ENERGY STAR®

Pool Pumps

Draft 2, Version 2.0/Version 3.0
Recommended Changes

Chuck Thomas
Technical Leader

184 | Figure 1. Connected Pool Pump System (CPPS)

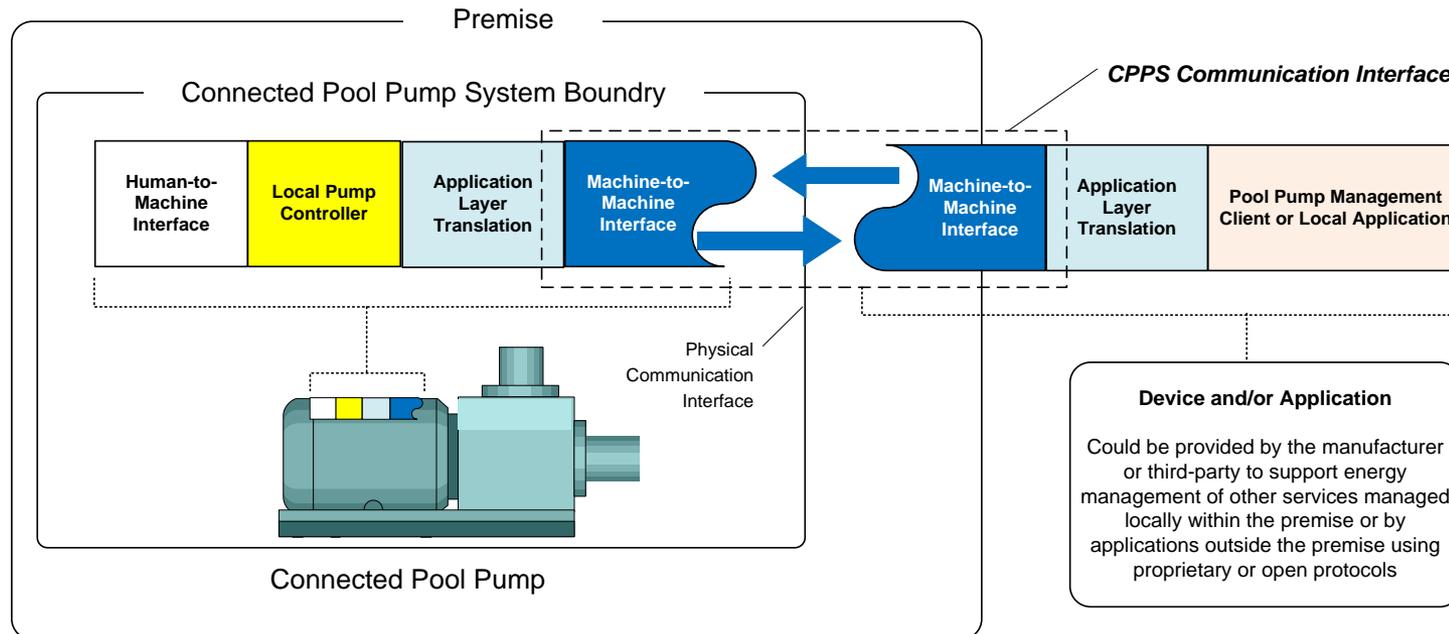
Recommendation is to change Figure 1 to provide a conceptual understanding of the requirements defined herein. The intent is to show that the open communication interface must be incorporated into the pump system located within the premise.

Recommend that the text throughout the document be changed from “one or more external applications, devices or systems” to “a device and/or application.”

177	1.6 Connected Products
178	A) Physical Communication Interface: As shown in Figure 1, the mechanism for bi-directional data
179	transfers between the CPPS and a device and/or application.

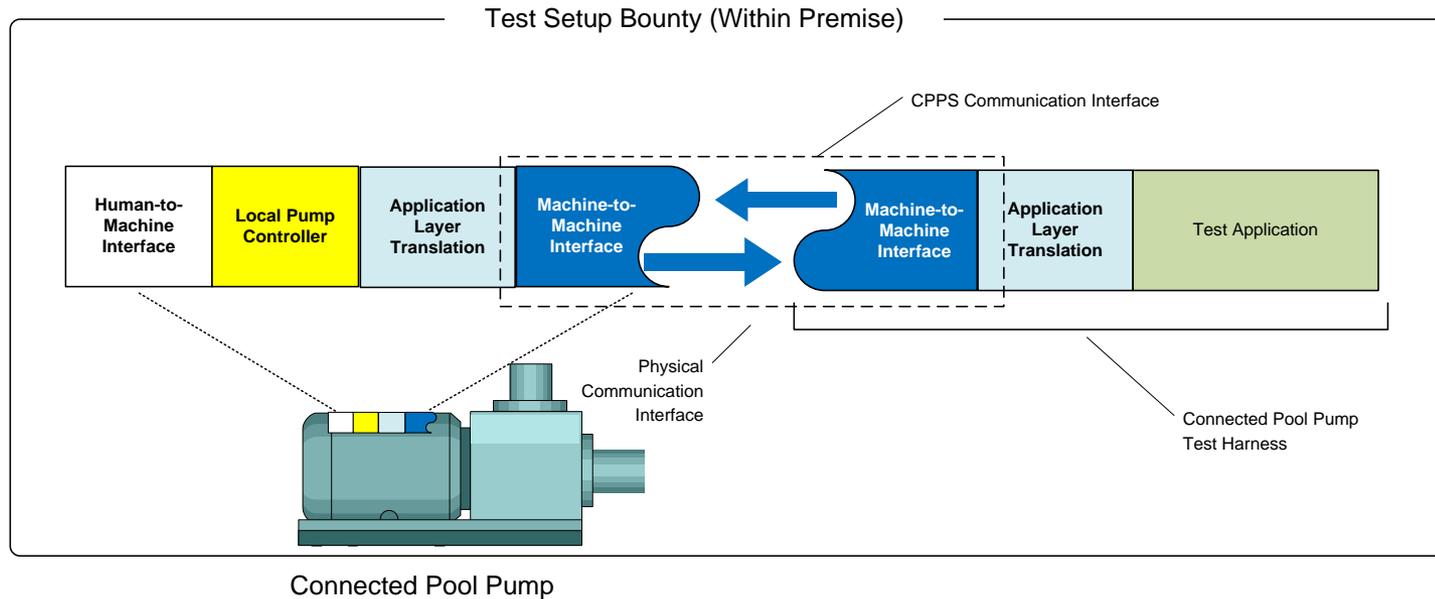
Since the test plan for connected functionality has not been developed, it's recommended that the above be used to define the "Test Harness"

If recommendations included are accepted, any third-party of independent test agency and test the pump and connected functionality locally, at the pump, without having to contact the manufacturer.

The test harness(s) could be standardized and used by OEMs to develop and test their technologies prior to submission, helping to ensure interoperability between technologies tested against the same test harness.
